AGENDA
MORGAN COUNTY BOARD OF COUNTY COMMISSIONERS
Assembly Room, Administration Building
231 Ensign Street, Fort Morgan, CO 80701
Thursday, October 15, 2020

1. Erin Kress and Travis Hertneky/THEngineering, LLC – Applicant
Bullseye Holdings, LLC/Kevin Lamb- Landowner

Reason- Use by Special Review Application to operate and re-establish a Confined Animal Feeding Operation for no more than 9000 head pursuant to Section 3-180 (O) and Appendix B Table 3 of the Morgan County Zoning Regulations

Re: Bullseye Holdings, LLC Feedlot Special Use Permit

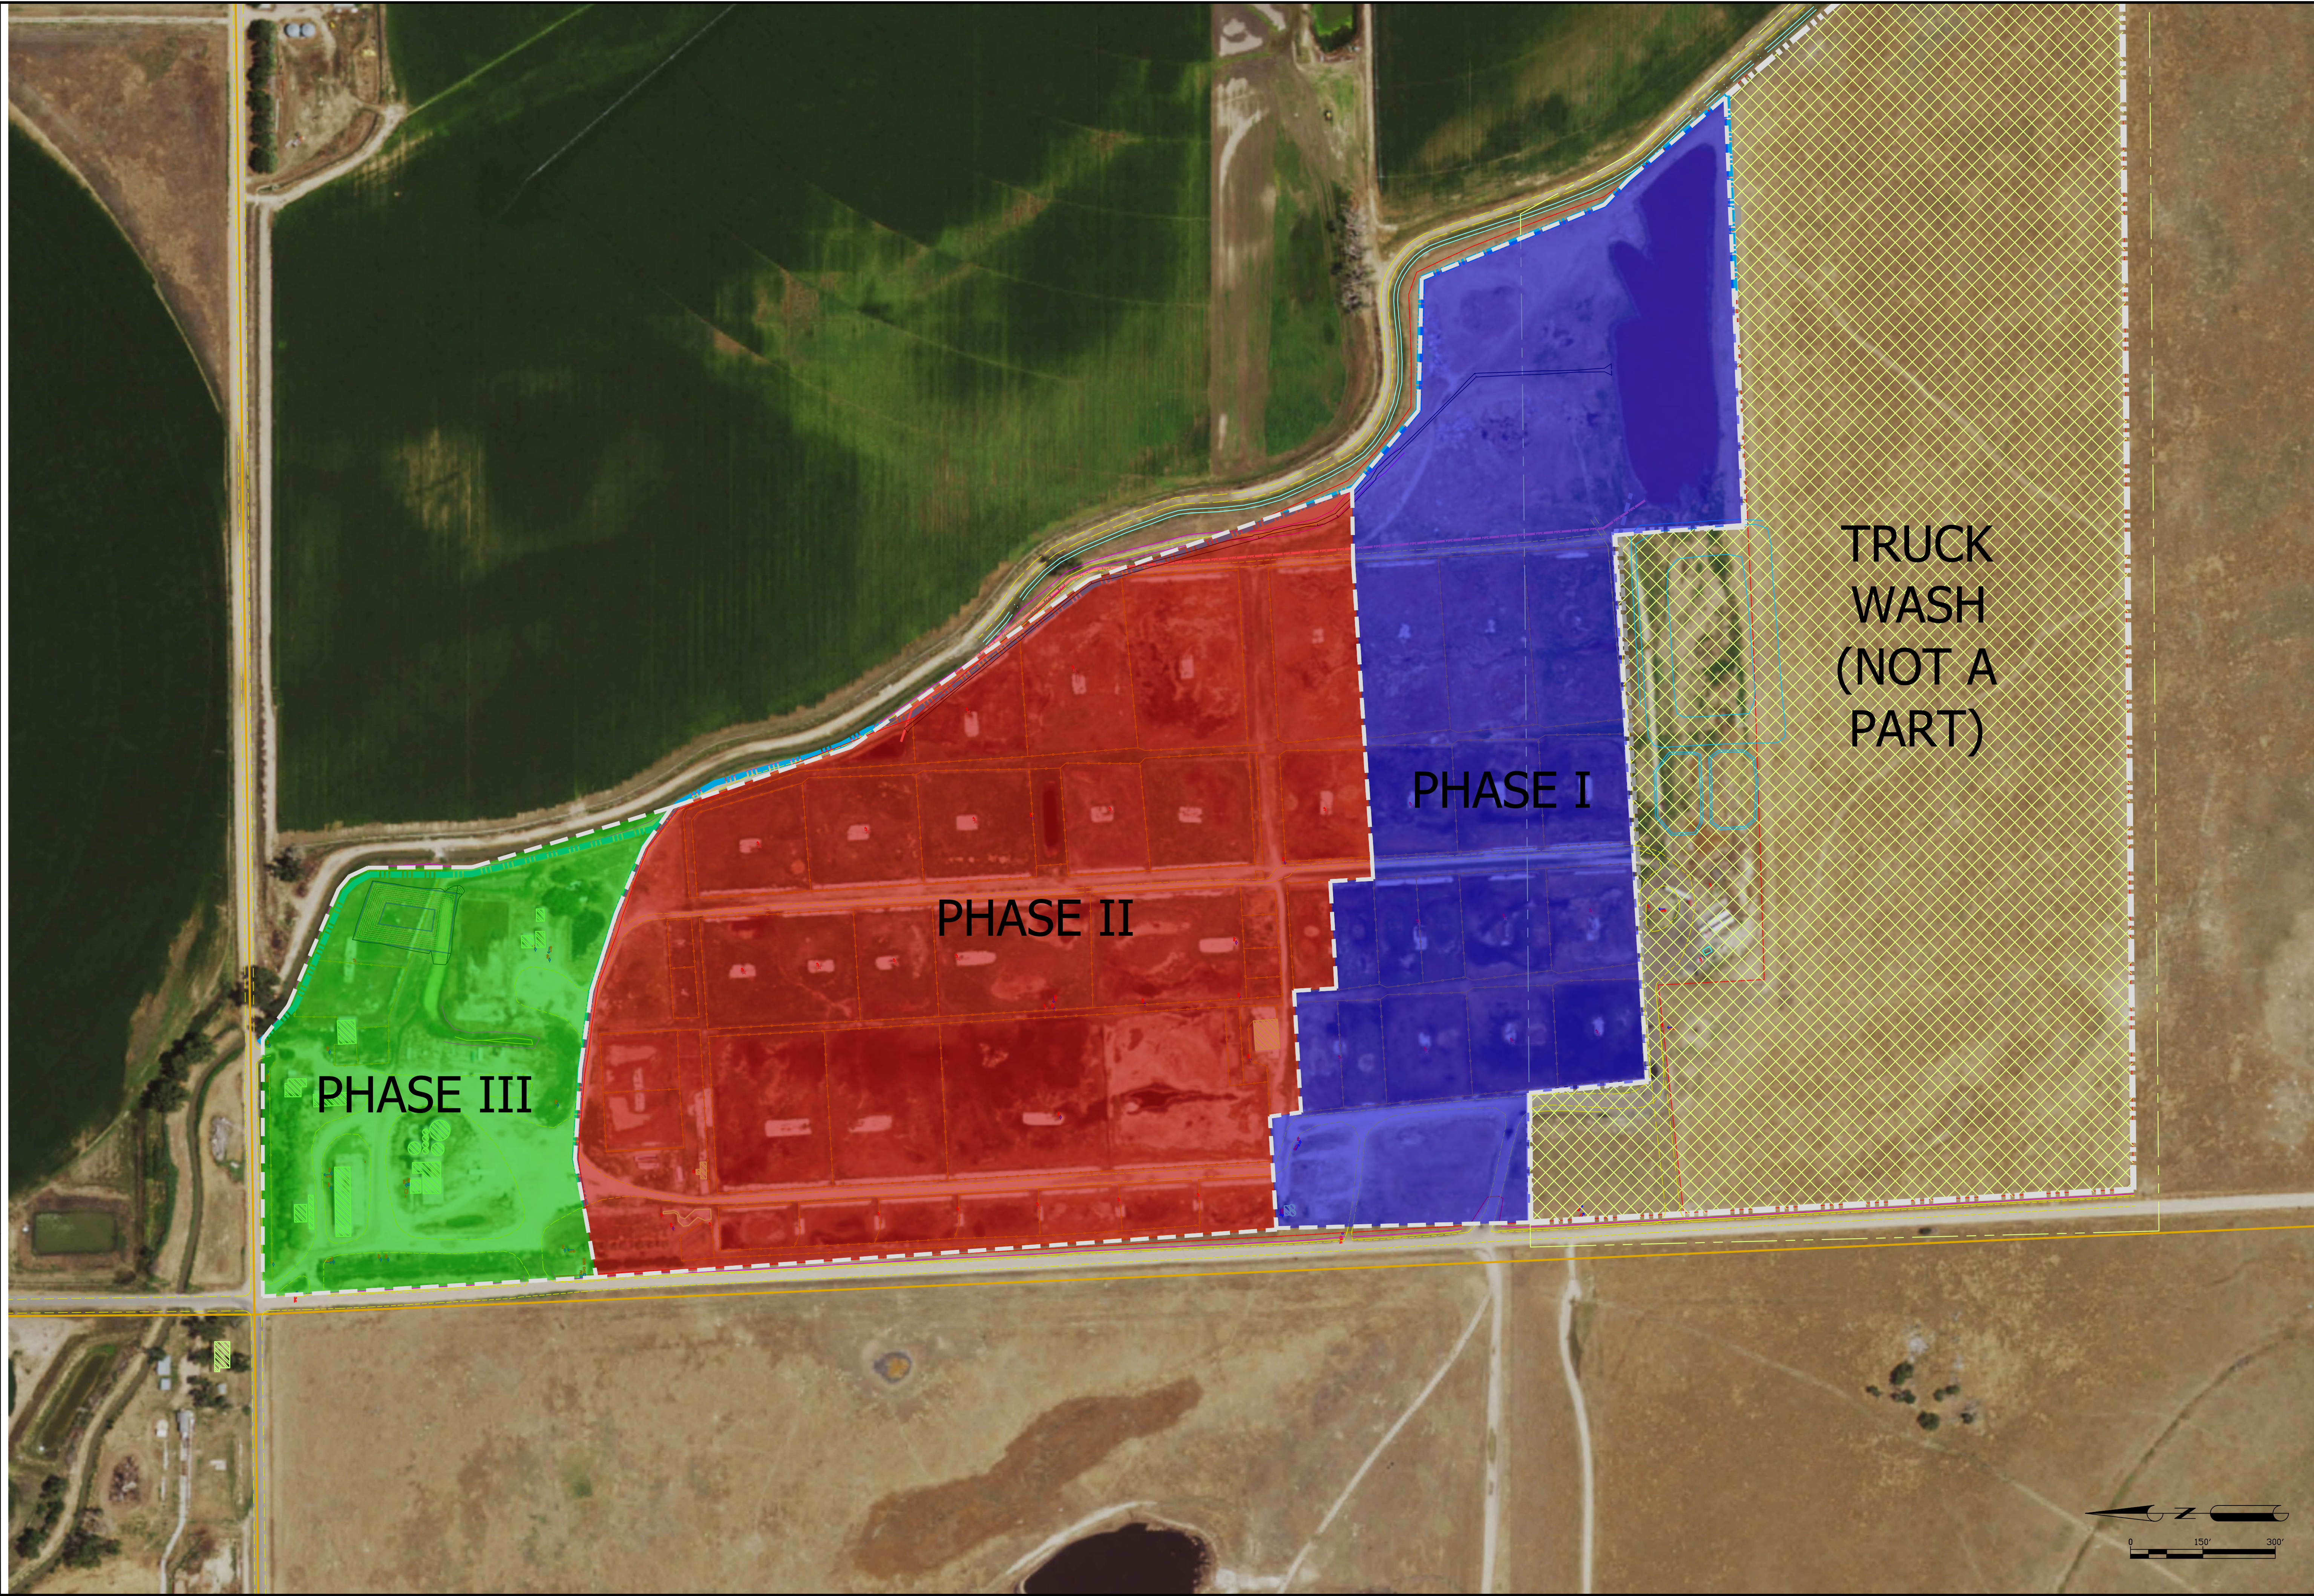
2. *Clearer diversion of stormwater conveyance without the usage of concrete bunkline for stormwater diversion or freeboard.*

The area directly adjacent to Bijou Canal and south of Pond #3 where a bunk prohibits the construction of a continuous earthen berm will have the concrete bunkline removed and re-located to the extent practical. The removal of this bunk allows the elevation of the earthen berm/road to be continuous and also allows the construction of an open channel that will discreetly convey stormwater from Pond #3 to Pond #1. This provides a discrete constructed channel that will convey stormwater and the capacity can be easily quantified.

The first item in your letter is the location of the emergency spillway. The proposed location on the south side of the dike is not directly connected to the Bijou Canal. This is acceptable to the company.

As part of the emergency spillway and stormwater control proposal, THEngineering has proposed a continuous dike on the east side of the site without the use of the feed bunk. We agree with this design criteria to help prevent overflow of wastewater into the Bijou Canal.

We have reviewed the stormwater storage that you are proposing in the August 24 letter and agree that the proposed total volume of 57.1 acre feet to the top of the berm and 27.5 acre feet to the 2 foot of freeboard is acceptable to the company. Provided the ponds and wastewater are managed properly through pump down of the pond, this should help prevent any overflow from a long-term rain event into the Bijou Canal.

Further details of this revised system can be found in the enclosures.

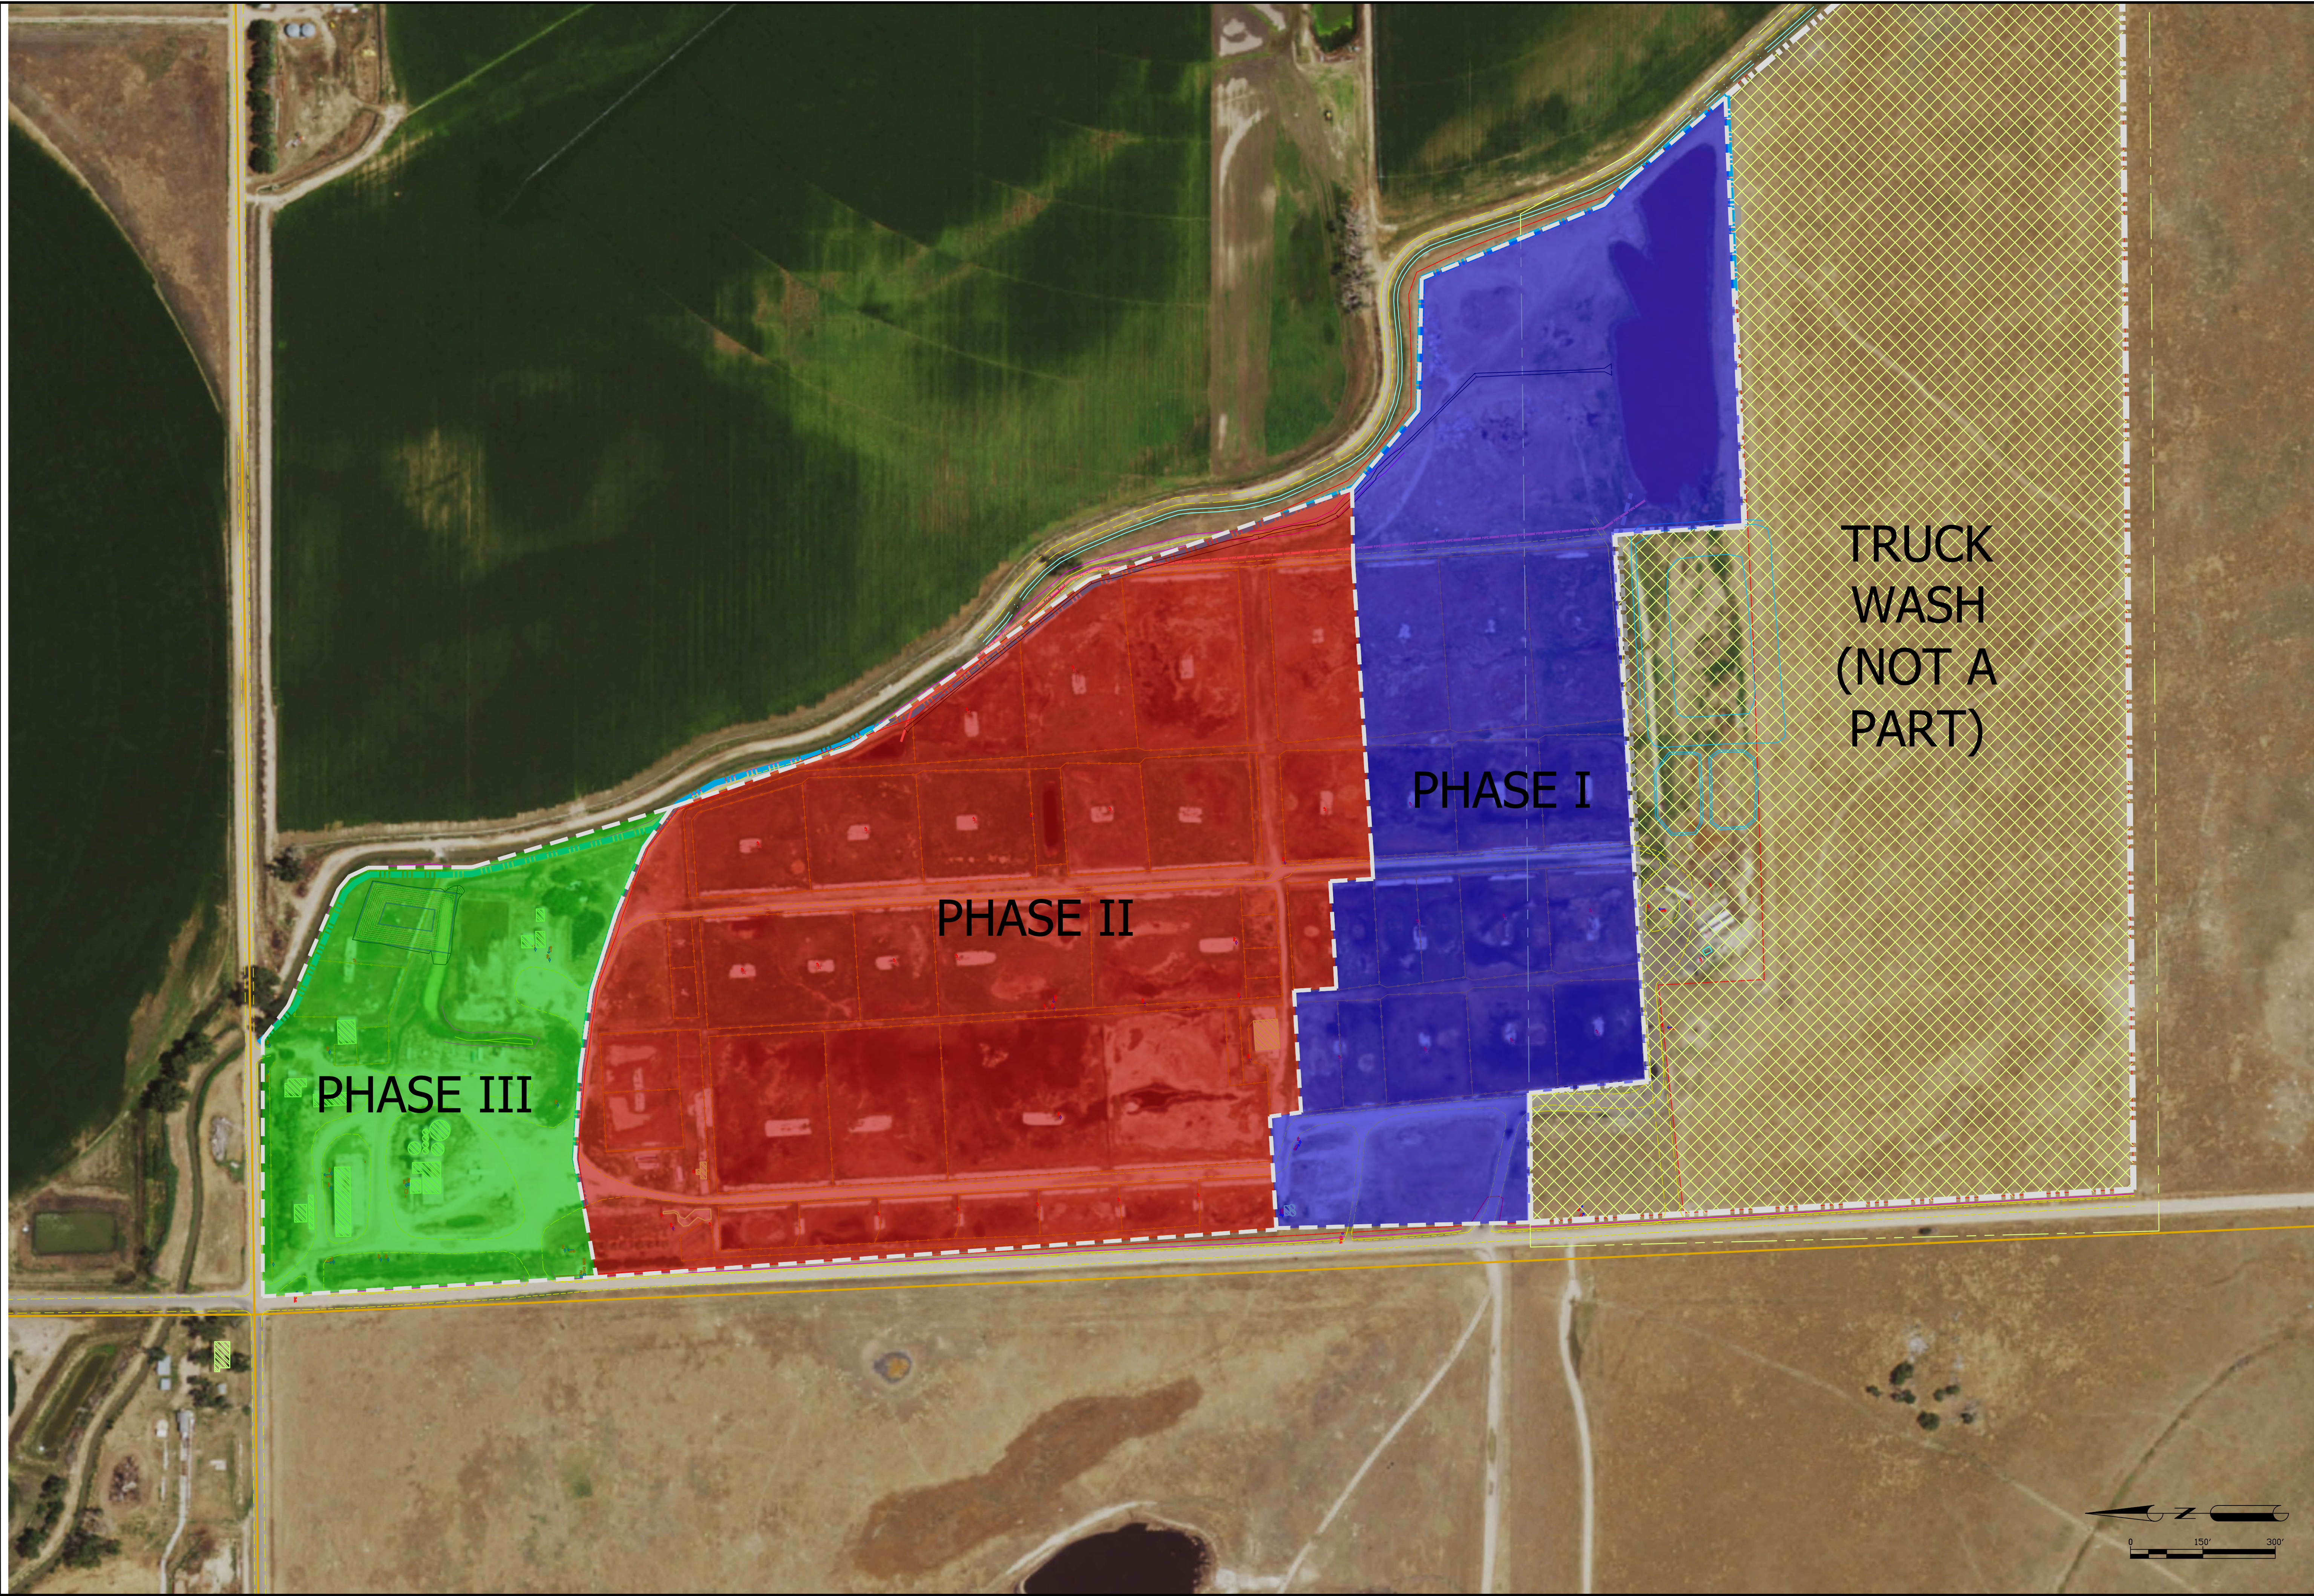
The additional berm that is planned for the east side of the Feedlot will remain and will be elevated an additional foot higher than previously planned along Pond #1. This additional foot of freeboard will create volume that will not normally be utilized except in extreme circumstances to provide the greater stormwater protections requested by Bijou.

This berm was previously proposed as a partial berm in the area where the current feed bunk does not allow the berm to continue and the concrete feed bunk would be used as a berm to provide additional freeboard when Pond #3 overflows to Pond #1. As a result of concerns with the use of this bunk as part of the berm by the Morgan County Commissioners, this portion of bunk will be removed to allow for a continuous berm along east edge. The removal of this bunk will also allow the construction of a discrete overflow channel that will convey the overflow from Pond #3 to Pond #1 without it flowing through the corrals. Projected runoff flows and channel capacity have been calculated and are included as an enclosure to this letter.
